BAW-10193NP-A

**RELAP5/MOD2-B&W For Safety Analysis of
B&W-Designed Pressurized Water Reactors**

SUBJECT: SAFETY EVALUATION OF TOPICAL REPORT BAW-10193P,
"RELAP5/MOD2-B&W FOR SAFETY ANALYSIS OF B&W-DESIGNED
PWRs" (TAC NO. M93346)

SAFETY EVALUATION BY THE OFFICE OF NUCLEAR REACTOR REGULATION

Figure 3. HPI Flow Rates Recorded During the Rancho-Seco Loss of ICS Power Event And Used in BAW-10193

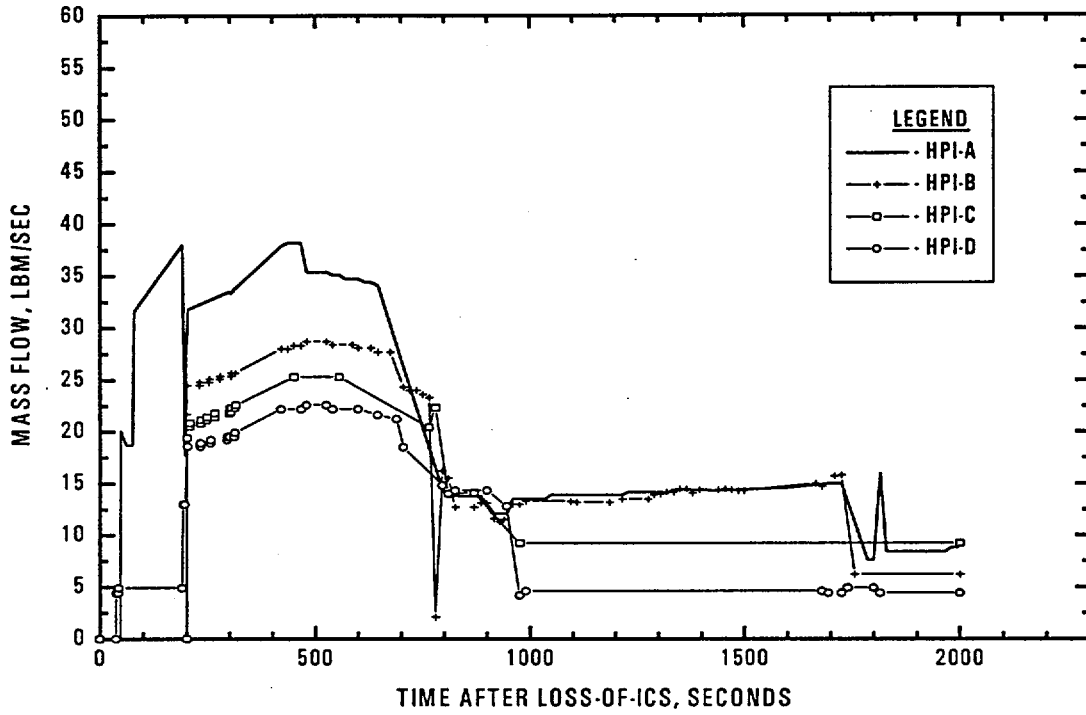
The code underpredicted the RCS repressurization, which FTG attributed to the uncertainty in measured HPI flows that were input in the benchmark calculation. In response to staff question 4 (Ref. 10), FTG reanalyzed RCS pressure response in the loss of ICS power event using an increased HPI flow. The results demonstrate that an increase in HPI flow has little effect on the pressure prediction during the depressurization because of the dominant effect of the RCS contraction caused by overcooling. However, once the cooling of the RCS was

Relative to the HPI flow measurement uncertainty, FTI did not perform a detailed uncertainty analysis. There is no accurate way to estimate the uncertainty. FTI inspected the HPI flow data (Figure 3) and reviewed the HPI system piping isometrics for Rancho-Seco. It appeared that the measured flow for the "A" loop was substantially greater than the other loops because the flow was delivered through an HPI nozzle as well as the make-up nozzle (lowered-loop B&W-designed PWRs use HPI pumps for normal makeup). There did not appear to be a good reason for the difference in flows between the "B", "C", and "D" loops. Therefore, the flows in the "C" and "D" loops were set equal to the values measured in the "B" loop (Figure 4) from the time of SFAS until the operator terminated flow in those loops (reported in the plant sequence of events as approximately 16.5 minutes). Reanalysis of the event yielded the pressure and pressurizer level predictions in Figures 5 and 6, respectively. Note that the pressure and pressurizer level predictions improve after 500 seconds, but prior to 500 seconds there is minimal change.

FIGURE 4-7. MEASURED AND PREDICTED PRIMARY OUTLET TEMPERATURES FOR THE 19-TUBE LOFW TRANSIENT.

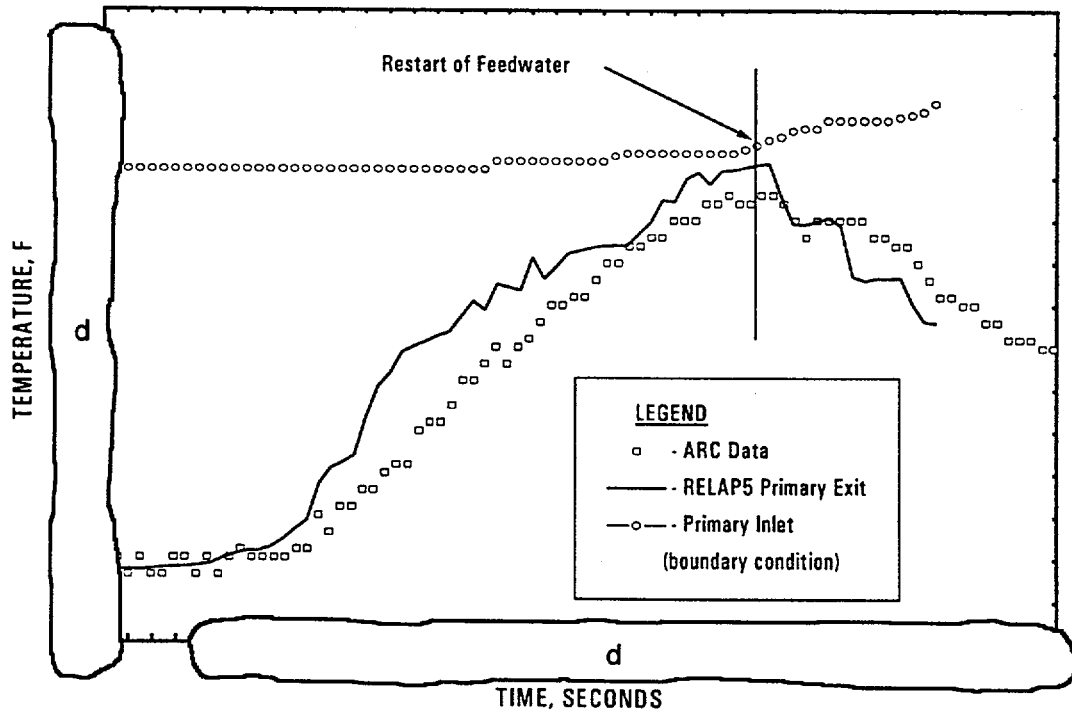
Figure 4-7 shows differences between the predicted and observed primary-side outlet temperatures. FTG attributed these differences to the heat capacity of the resistance thermal detector (RTD) used in the test. The RTD heat capacity caused a lag in the measured temperature response such that the actual fluid temperatures were higher than the recorded values during heatup and lower than the recorded values during the refill. In response to staff question 2 (Ref. 10), FTG performed a Laplace transform of the calculated primary-side outlet temperature to account for the RTD time constant. The adjusted temperature results show good agreement with the actual RTD output, demonstrating that, if a thermal lag were applied to the code prediction to account for RTD capacity, a good match would be obtained with the measured data. This indicates that the RELAP5/MOD2-B&W prediction of transient heat transfer is in good agreement with the test, as demonstrated by the good agreement between the predicted and measured steam flow. The benchmarks demonstrate that RELAP5/MOD2-B&W with the control volume arrangement used in this benchmark can predict the shell-side

2) With regard to the OTSG LOFW test, because the test used the same equipment as the IEOTSG test, the RTD thermal lag applies to the OTSG LOFW test. As stated above, the lag constant is approximately [d] seconds. Figure 2 shows a comparison of the primary outlet temperature recorded at the test with the RELAP5/MOD2-B&W prediction from Figure 4-7 in BAW-10193. Also shown is the code prediction of primary outlet temperature after it was run through a Laplace transform that simulated a [d] lag. The adjusted temperature—which mimics the value that would be observed if the RELAP5/MOD2-B&W predicted outlet temperature was "measured" by the RTD—agrees well with the actual RTD output. This indicates that the RELAP5/MOD2-B&W prediction of transient heat transfer is in good agreement with the test. This is consistent with the predicted steam flow shown in Figure 4-6 of BAW-10193. The measured steam flow provides a direct indication of the primary-to-secondary heat transfer following a LOFW. The RELAP5/MOD2-B&W prediction compares well with the data.

FIGURE 4-10. MEASURED AND PREDICTED STEAM FLOW FOR THE 19-TUBE IEOTSG LOFW TRANSIENT.

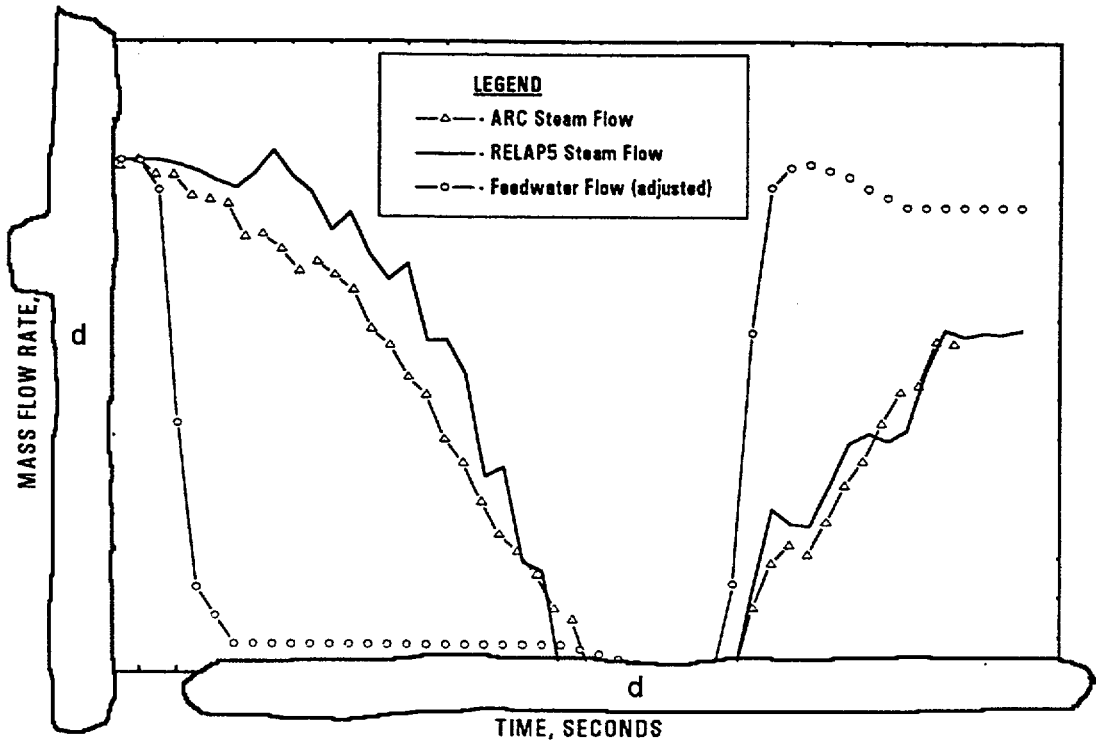
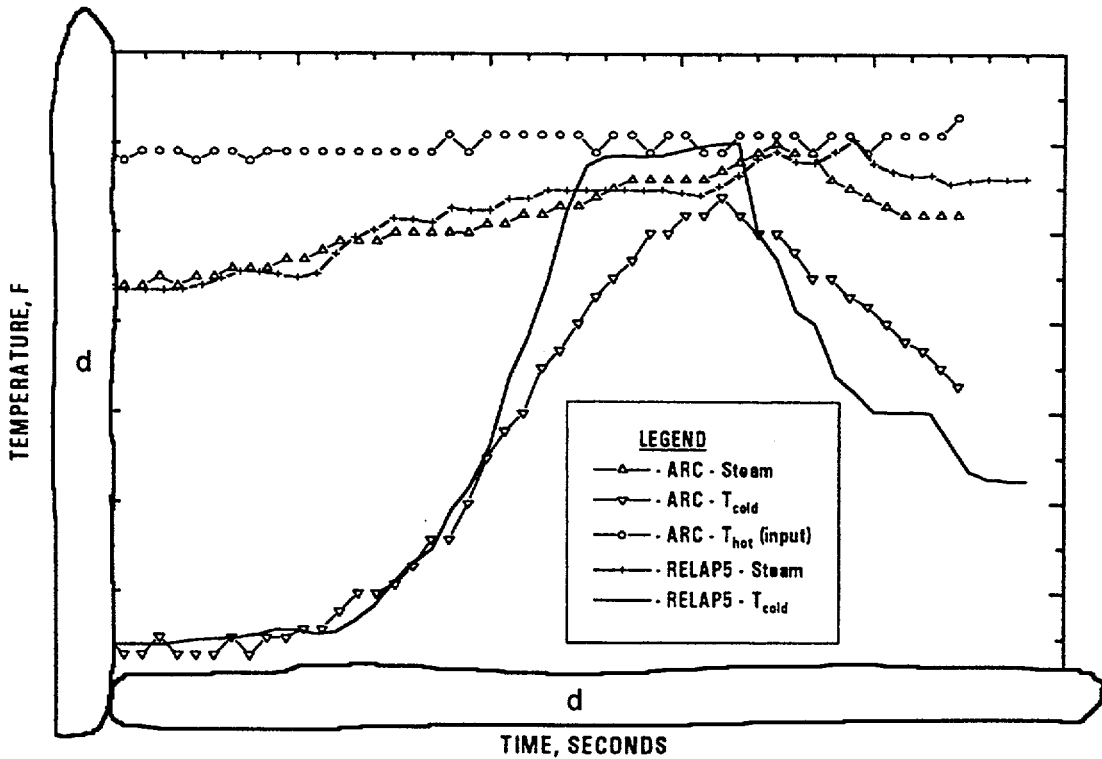
Figure 4-10 shows the code prediction of dryout time to be 2 seconds less than the observed time. This is because the code overpredicted the steam flow from the IEOTSG during the dryout period. This results in early dryout and a low prediction of primary outlet temperature caused by an overprediction in heat transfer. The overprediction of steam flow arose as the mixture level crossed the control volume boundaries. FTG concluded that the noding detail used to predict the IEOTSG test data is too crude to produce an accurate result and that additional modeling is required. FTG, in its response to staff question 2 (Ref. 10), indicated that the benchmark will not be refined at this time, because it has no plans to perform IEOTSG plant safety analysis. FTG stated that before (or concurrent with) the licensing submittal of an IEOTSG plant safety analysis, it will submit an updated benchmark of these test data for NRC review. The staff concludes that RELAP5/MOD2-B&W may not be used for the safety analyses of PWRs with IEOTSGs until FTG submits and the staff accepts an updated benchmark of the IEOTSG LOFW test case.

Figure 4-10 in BAW-10193 shows that there was a time delay between restart of feedwater and restart of steaming. If the downcomer pipe was full, as it should have been, then steaming would have started immediately upon feedwater restart. We postulated that the time delay observed in the test was the time required to refill the downcomer pipe to make up for the mass lost during the test. The mass lost from the downcomer pipe was estimated by multiplying the feedwater flow at 35 seconds times the time delay of about 1.5 seconds. The resulting mass [c, d] was transferred from the downcomer pipe to the tube bundle over approximately 22 seconds, as shown in Figure 4-10 of the topical report.

Table 4-5 and Figures 4-10 and 4-11 of BAW-10193P show the benchmark results of the IEOTSG LOFW transient. The RELAP5/MOD2-B&W predictions of the steam temperature and the primary outlet temperature agree well with the test data for the first 20 seconds of the transient. After 20 seconds, a deviation occurs when the predicted primary outlet temperature rapidly approaches the inlet temperature as the IEOTSG dries out, but the observed temperature remains much lower than the inlet temperature, indicating continued heat transfer. FTG stated that the continued heat transfer is not supported by the measured steam flow, and that the deviation between the predicted and observed temperatures is primarily due to the RTD heat capacity.

- B. *Figure 4-11 shows a deviation between the predicted and the observed steam generator primary outlet temperatures after 20 seconds where the predicted temperature rapidly approached the inlet temperature as the IEOTSG dried out, and the observed temperature remained much lower than the inlet temperature, indicating continued heat transfer. You stated that the continued heat transfer is not supported by the measured steam flow, and that the deviation between the predicted and the observed temperatures is primarily due to the RTD heat capacity, which caused a lag in the measured temperature response such that the actual fluid temperatures were higher than the recorded values during heatup and lower than recorded values during refill. (1) Provide an estimate of the lag in temperature measurement due to RTD heat capacity and exam whether the deviation is entirely caused by this effect. (2) Explain whether the RTD heat capacity effect also applies to the temperature measurement in the OTSG LOFW test.*

- 1) The lag constant on the RTDs is estimated to be approximately [d] seconds. To determine what the observed values would be if the RELAP5/MOD2-B&W predictions were "measured" by the RTDs, the code prediction of primary outlet temperature in Figure 4-11 of the topical report was run through a Laplace transform that simulated a lag of five seconds. Figure 1 (attached) shows the resulting adjusted temperature. When compared with the test data, the adjusted temperature prediction is consistent with the steam flow prediction. In other words, RELAP5/MOD2-B&W overpredicts the steam flow during the dryout portion of the test. This should result in early dryout—as observed in Figure 4-10 in BAW-10193—and should result in a low prediction of primary outlet temperature caused by an overprediction in heat transfer. In fact, the adjusted RELAP5/MOD2-B&W temperature prediction shows this trend as compared with the measured values. FTI concluded that the noding detail used to predict the IEOTSG test data is too crude to provide an accurate result and that additional modeling is required.

FIGURE 5-10. TEMPERATURE COMPENSATED PRESSURIZER LEVEL FOR THE TMI-2 LOFW EVENT.

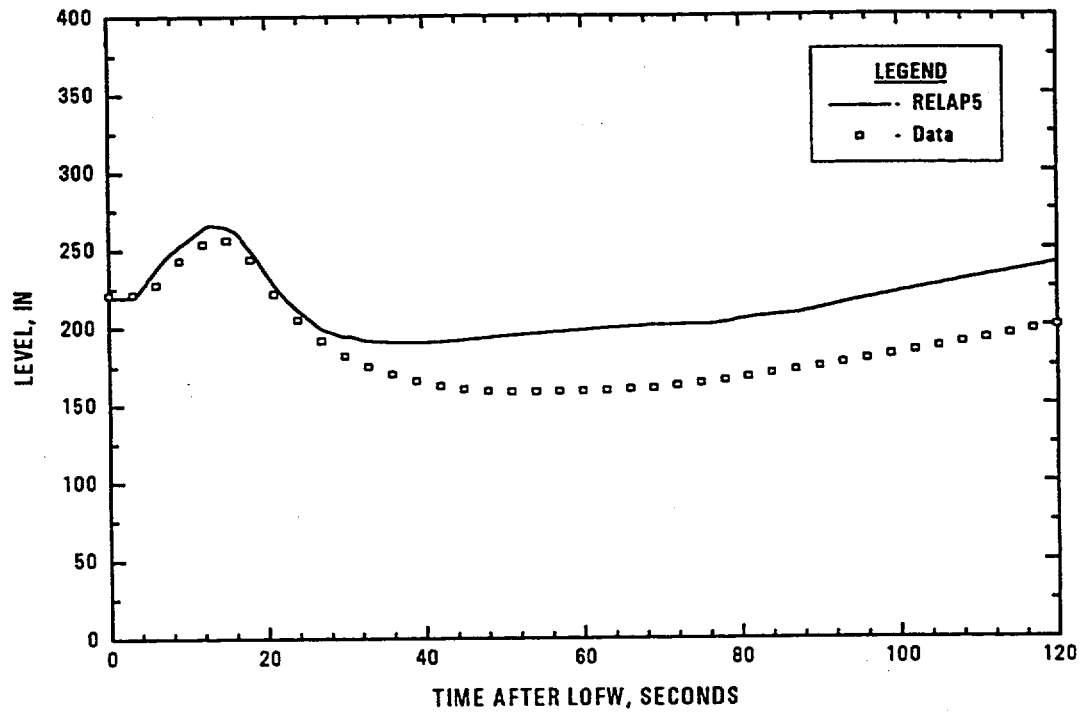
Regarding the RELAP5/MOD2-B&W analysis of the TMI-2 LOFW event, Figure 5-10 indicated agreement between the code prediction of the pressurizer level and the plant data up to the reactor trip at about 20 seconds. After the reactor trip, the code overpredicted the plant data. You concluded, based on the experience with the B&W plants showing the pressurizer level should decrease by 5.5 inches for every degree decrease in average system temperature, that the plant data are probably not reliable during this period. Are the pressurizer level data prior to the reactor trip reliable, and why? What conclusion can one draw when the code predictions are in good agreement with the plant data if the data are not reliable?

FIGURE 5-20. STEAM GENERATOR OPERATE RANGE LEVEL FOR THE TMI-1 NATURAL CIRCULATION TEST.

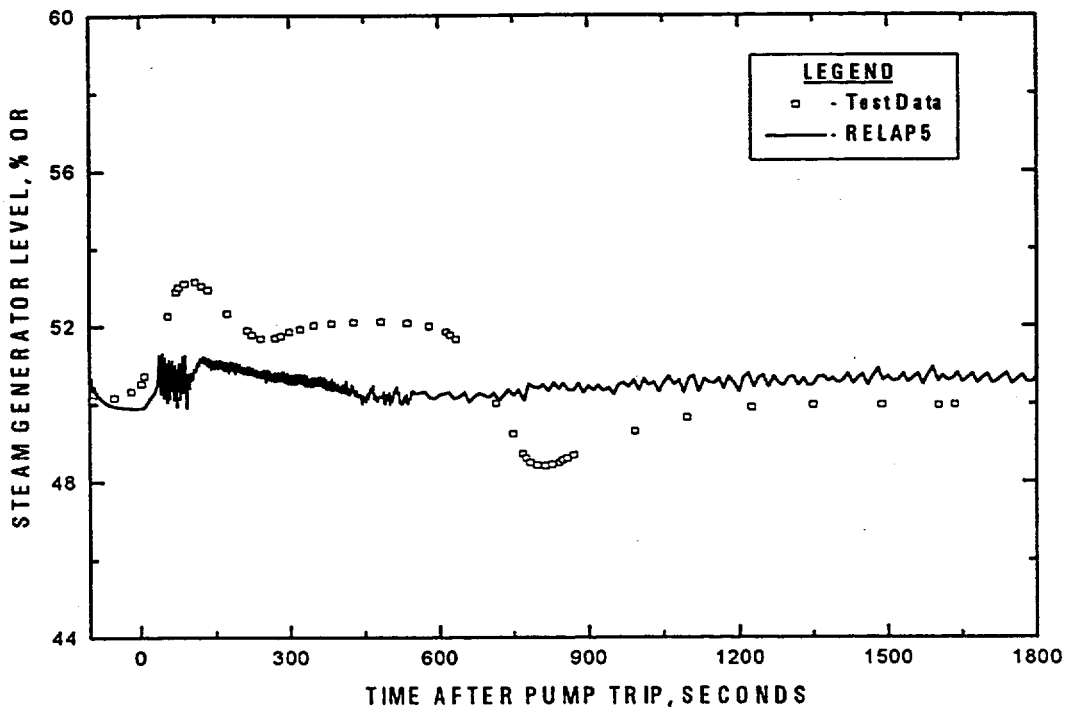
- B. *Explain why (1) the RELAP5/MOD2-B&W input of the setpoints shown in Table 5-14 for the pressurizer heater banks 3 and 4 are 15 psi lower than the plant setpoints, and (2) the input steam generator level boundary condition shown in Figure 5-20 is different from the plant data.*

In regard to the steam generator level boundary condition, no attempt was made to mimic the level observed in the test. The plant control system maintained the steam generator level at 50 percent \pm 2 percent. Four percent on the operate range level indication corresponds to approximately 12 inches, which is less than the height of a steam generator control volume (approximately 5 feet) in this region of the steam generator model. Because this small variation in water level has no effect on the calculation, a simplified control system was used in the simulation to maintain the steam generator level near 50 percent (the target value for the test).
